CSNHS-M002-00(965)
Pavement Rehabilitation for
Interstate I-75 from the State Route 5 Connector
P.I. No. M002965
Cobb, Cherokee, and Bartow Counties, Georgia

Value Engineering Study Report
Concept Design Stage
September 2004

re: Project Number CSNHS-M002-00(965),
I-75 from S.R. 5 Connector to S.R. 61/U.S. 411 in
Cobb, Cherokee, and Bartow Counties, Georgia
Value Engineering Study Report

DESCRIPTION: **USE RIGID PAVEMENT FROM BARRETT PARKWAY TO** SHEET NO.: 1 of 7
GLADE ROAD

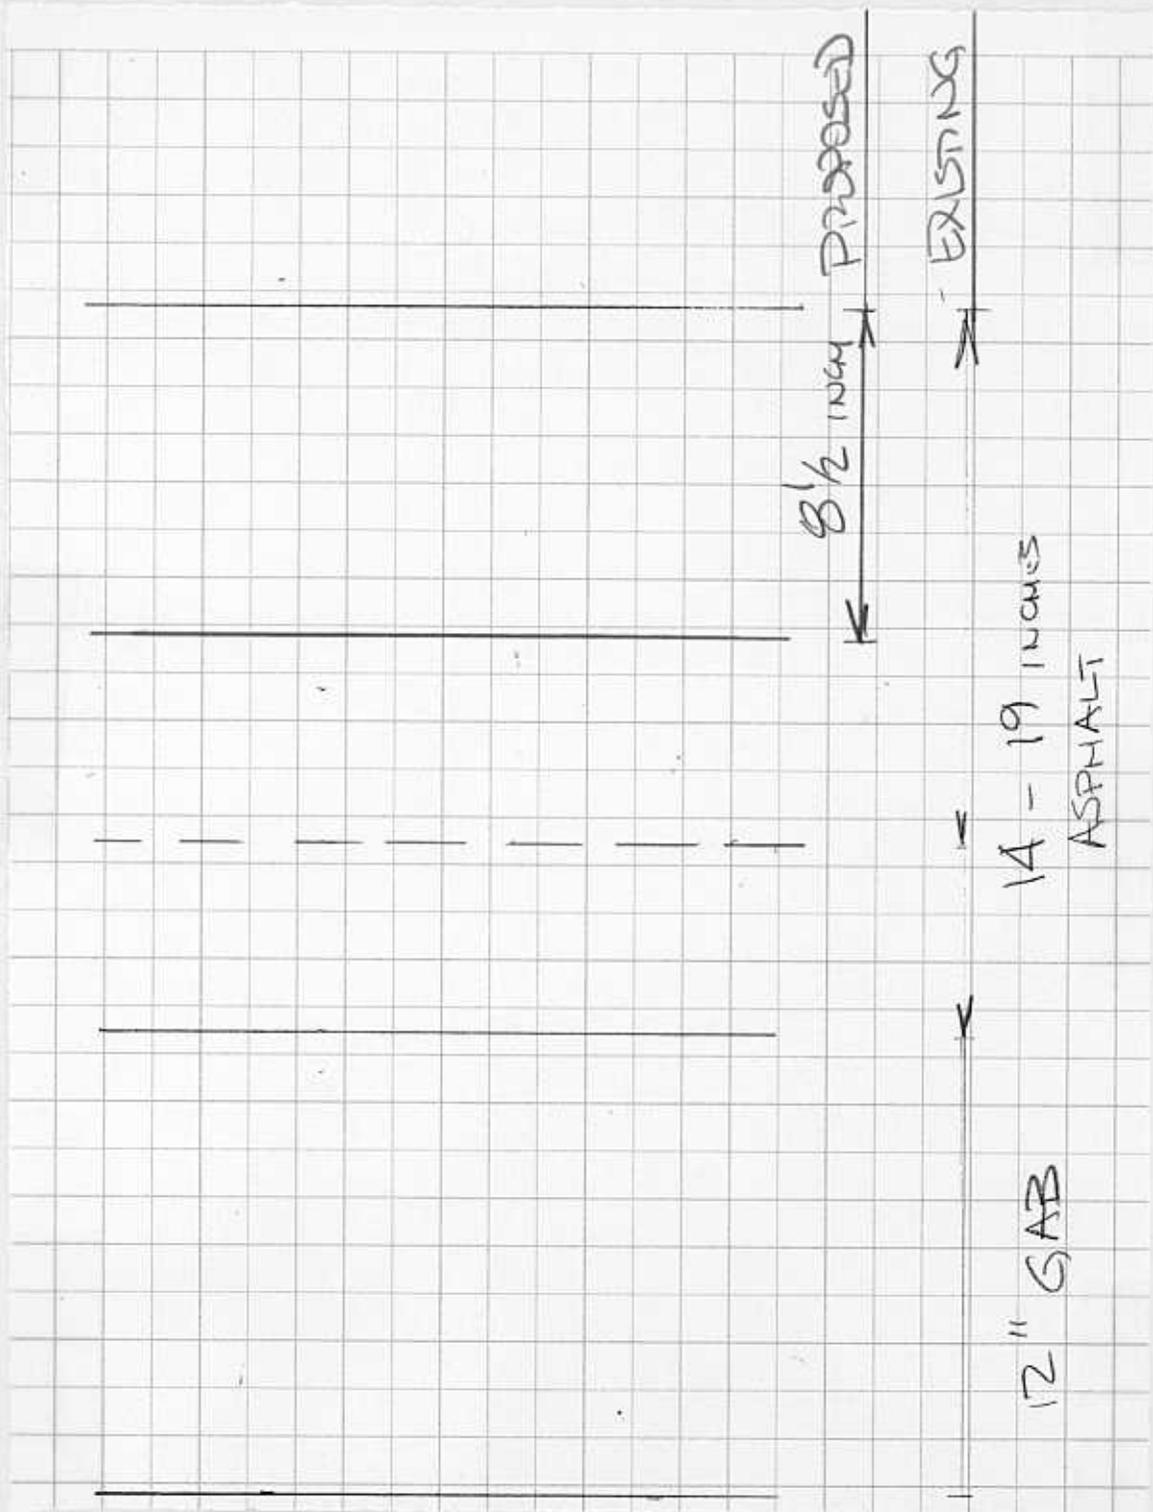
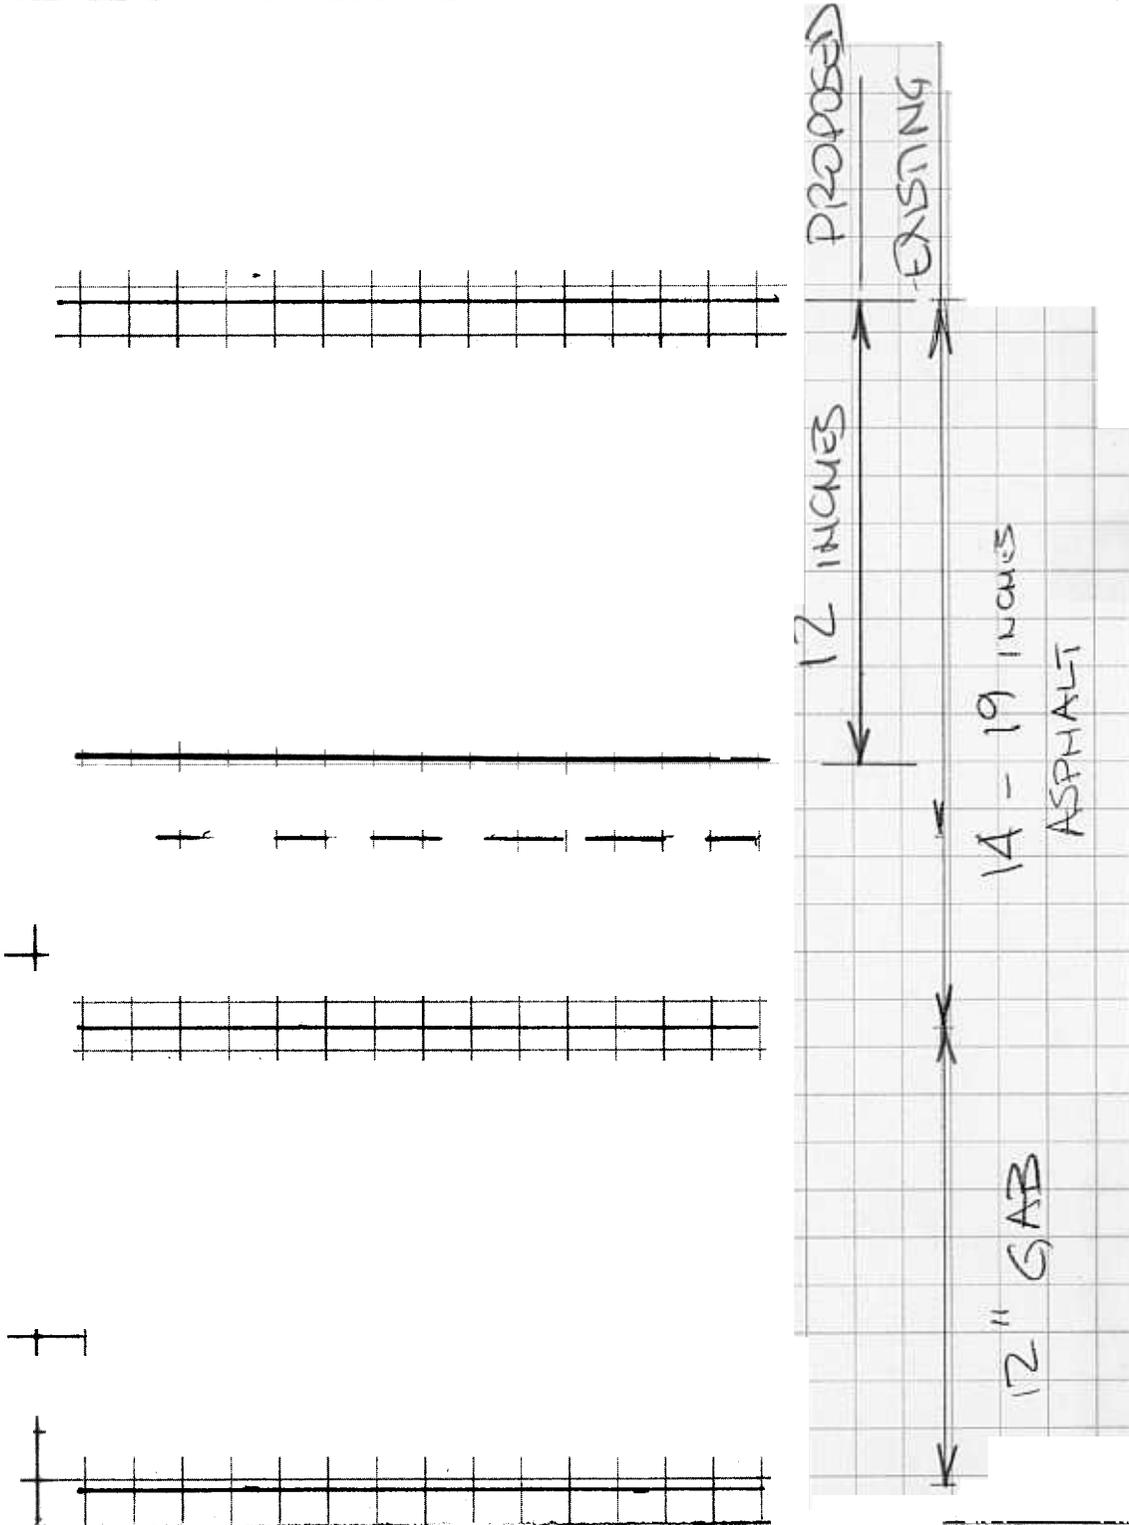
The current concept is to provide a full-depth asphalt pavement from Barrett Parkway (SR5 Connector) to Glade Road. Mill 8½ in. and construct asphalt.

Construct full-depth 12-in. thick concrete pavement in lieu of asphalt from Barrett Parkway to Glade Road only. The segment of the project from Glade Road to the terminus at the SR61/US411 Interchange is to remain asphalt pavement.

This alternative would construct concrete pavement rather than asphalt pavement described in the preliminary pavement report. While this alternative is certainly more costly initially, the overall maintenance costs are lower and most significantly, the lifespan of the concrete is longer than the asphalt, thereby not requiring additional resurfacing every 7 - 10 years. This section was last resurfaced in 1994 based on information provided by GDOT during the information gathering phase. Thus it has reached the end of its useful life.

DESCRIPTION: **CONSTRUCT FULL-DEPTH INSIDE SHOULDER FOR STAGING**

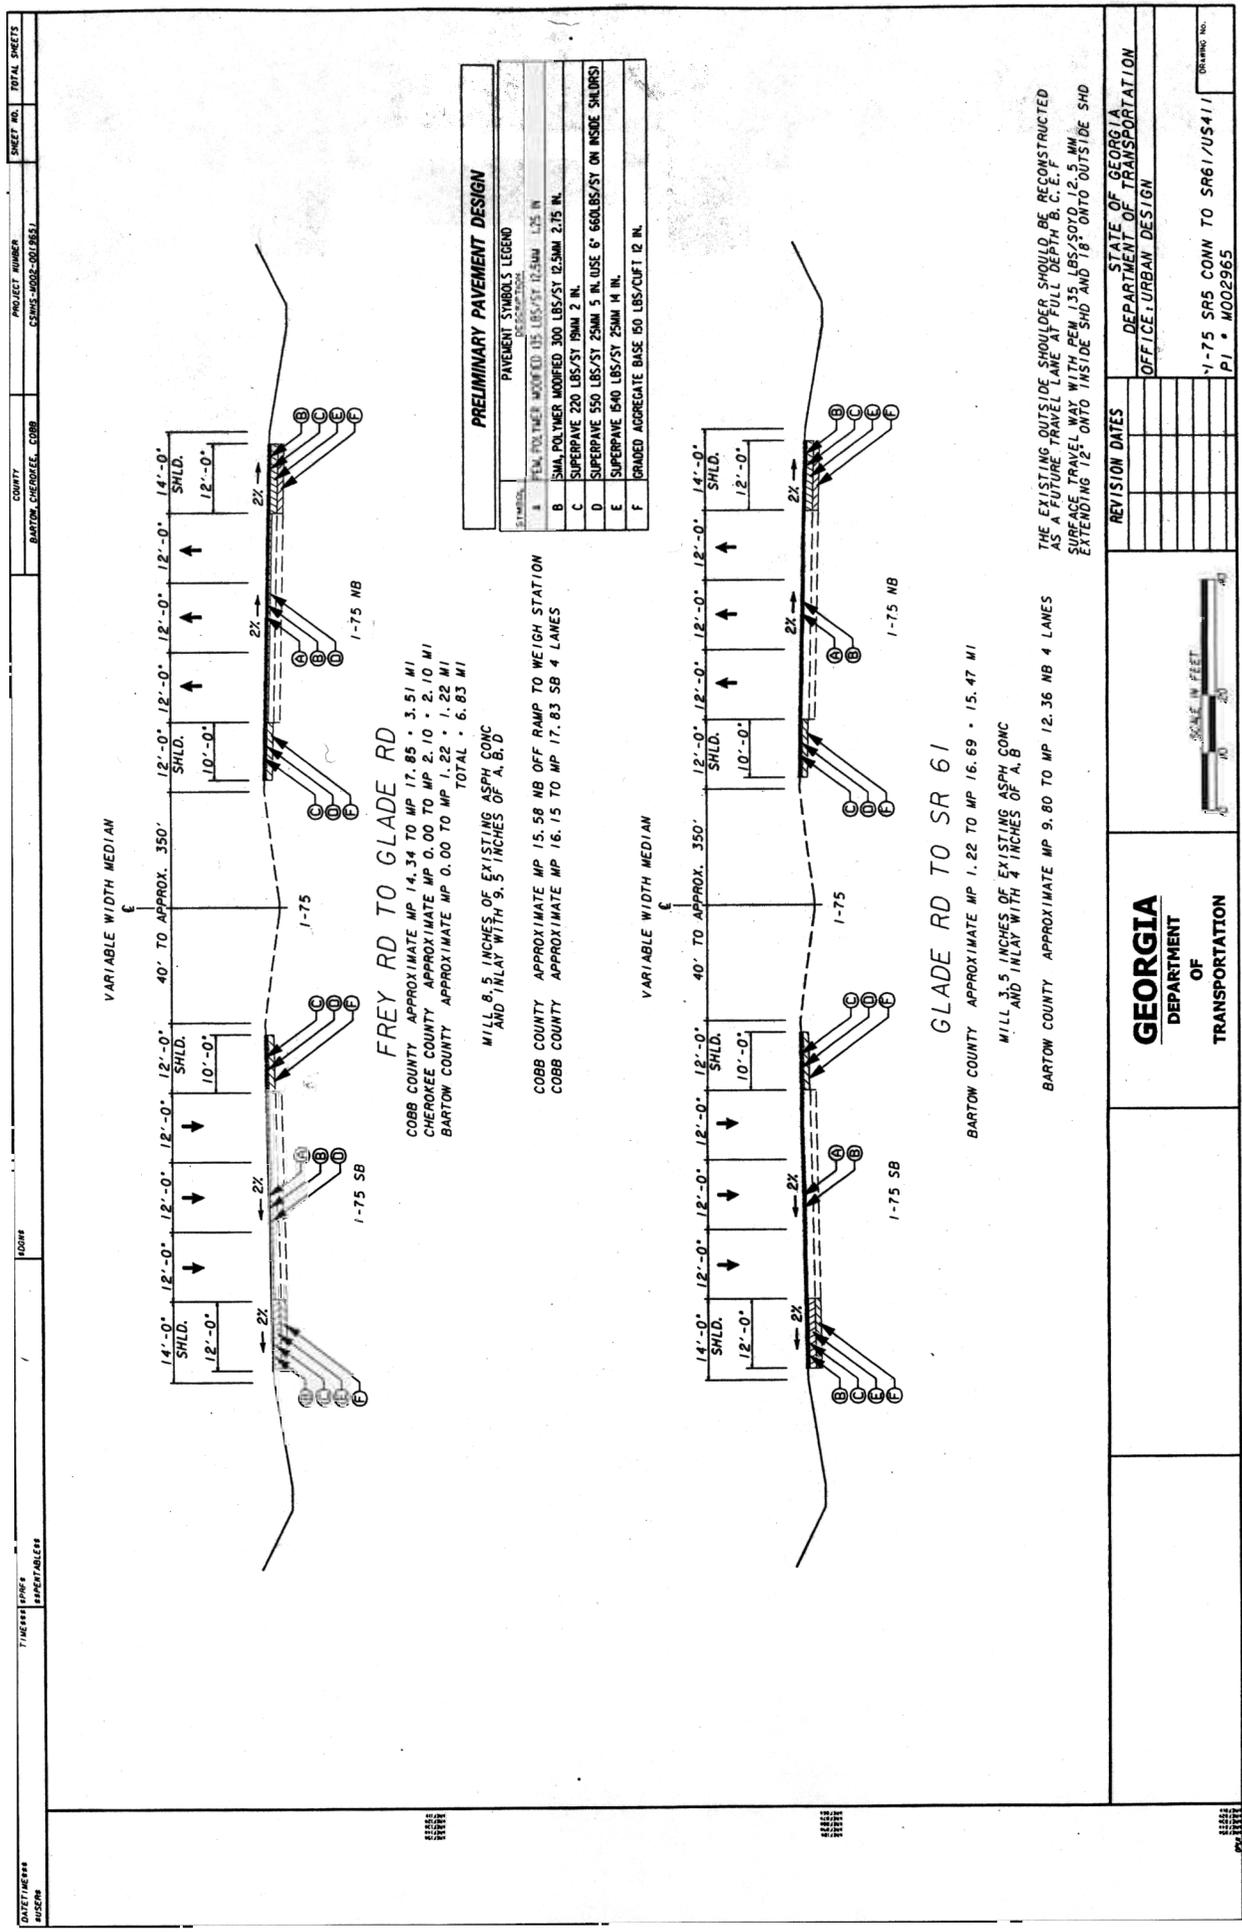
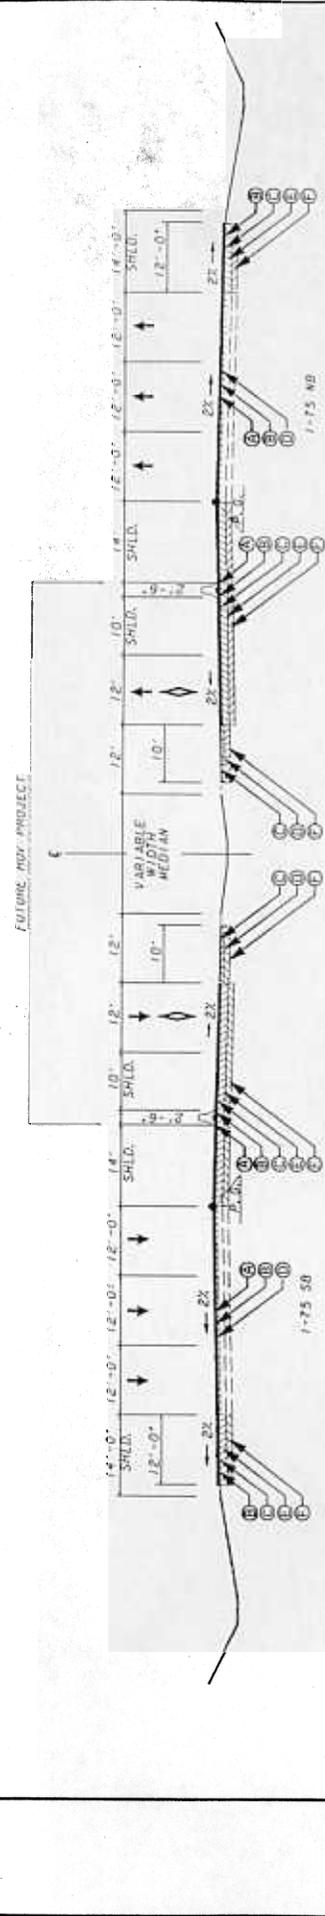
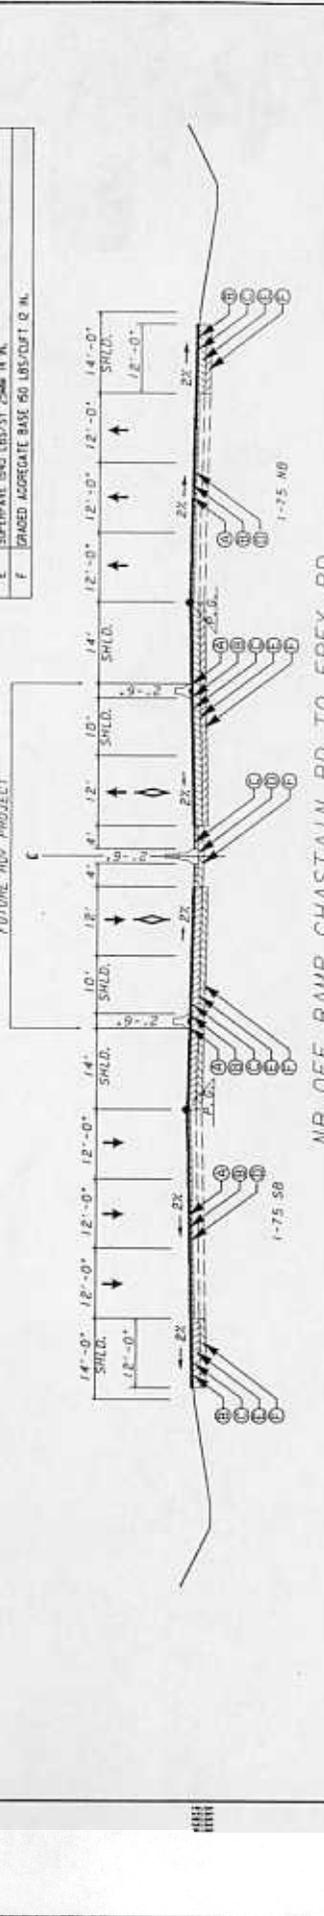
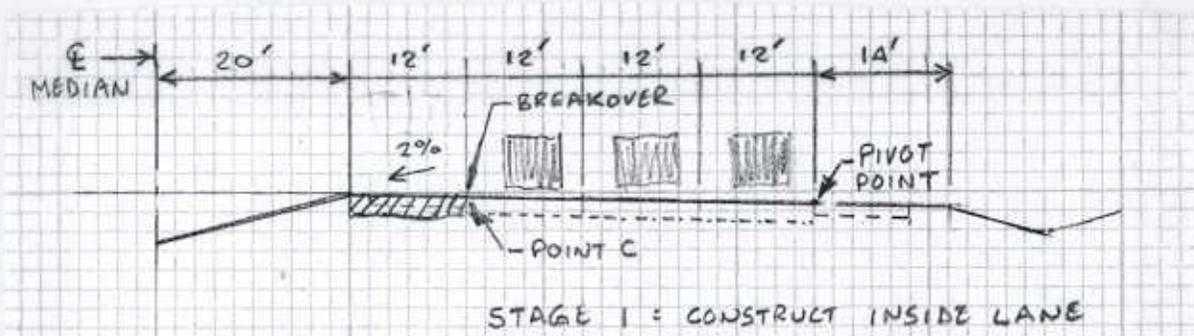
The original design mills and replaces three lanes of traffic and constructs a full-depth outside shoulder and a median shoulder (not full-depth).

The construction sequence attached changes the median shoulder to full-depth to facilitate staging.

In the attached sequence, the inside shoulder would be constructed first. According to Dickey Forrester, PE, Construction Liaison Engineer for Districts 1 and 6, the inside shoulder can be constructed with traffic running in the existing inside lane with barrels and/or vertical panels for traffic control (no concrete temporary barrier) so long as the following conditions are satisfied:

1. Only 1,000 lf of shoulder at a time can be opened to sub-grade depth to limit the length of roadway with an adjoining drop-off.
2. Lengths of shoulder beyond this limit can be cut to sub-grade depth as long as the drop-off is healed to reduce the limits to 1,000 ft. (detail attached).

SHEET NO.: 5 of 11

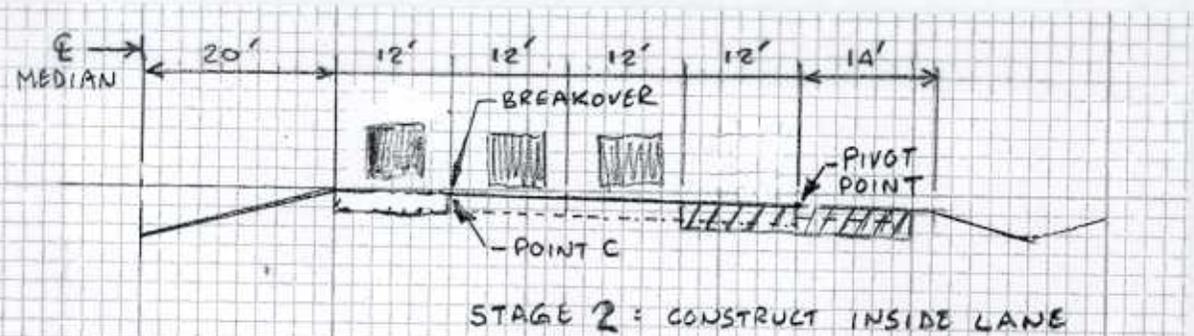
1. RECONSTRUCT INSIDE SHOULDER AS FULL DEPTH TRAVEL LANE
2. SLOPE INSIDE SHOULDER AT 2% TOWARDS THE MEDIAN
 , MATCHING EDGE OF EXISTING LANE AT POINT C

1. SHIFT TRAFFIC TO INSIDE
2. MILL AND REPLACE OUTSIDE EXISTING LANE
3. RECONSTRUCT OUTSIDE SHOULDER AS FULL DEPTH LANE

SHEET NO.: 6 of 11

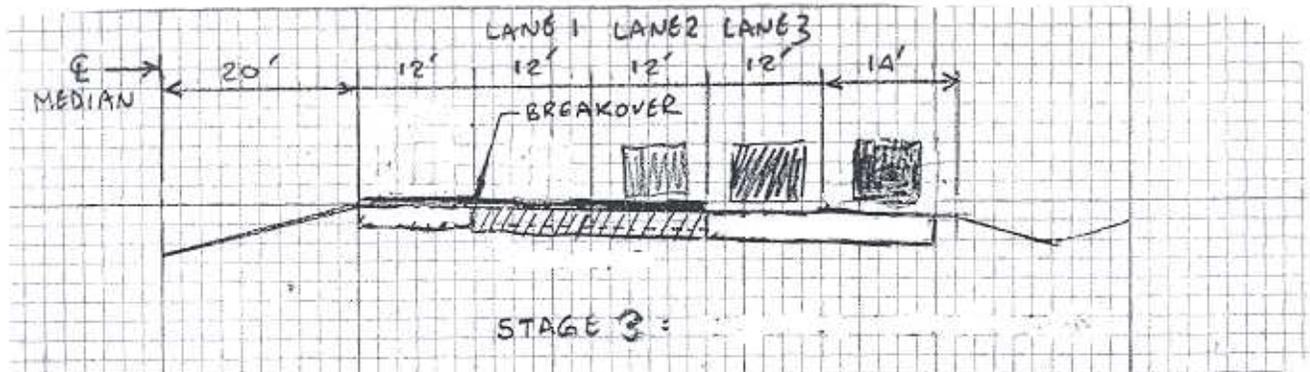
1. SHIFT TRAFFIC TO OUTSIDE
2. MILL AND REPLACE TWO EXISTING LANES (INSIDE)
 LANE 1 CAN BE DONE WITHOUT WORKING RESTRICTIONS
 LANE 2 MUST BE DONE UNDER OFF PEAK HOUR
3. OVERLAY TO FINAL GRADE IN INSIDE SHOULDER
 AND LANE 1 (NO WORKING RESTRICTIONS)
4. OVERLAY TO FINAL GRADE LANE 2 IN OFF-PEAK
 HOURS

OVERLAY THICKNESS REQUIRED @ POINTS TO INCREASE
 CROSS-SLOPE TO 2%

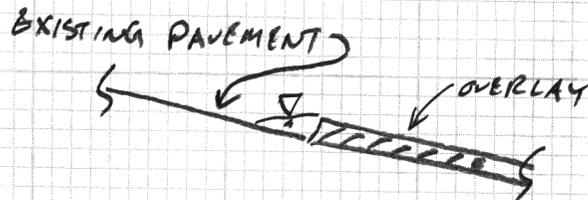
IT IS IMPORTANT TO NOT CREATE AN AREA TO
 CATCH WATER IN THE OVERLAY OPERATION.

PAVING FROM THE HIGH (INSIDE) TO THE OUTSIDE
 WILL PREVENT THIS
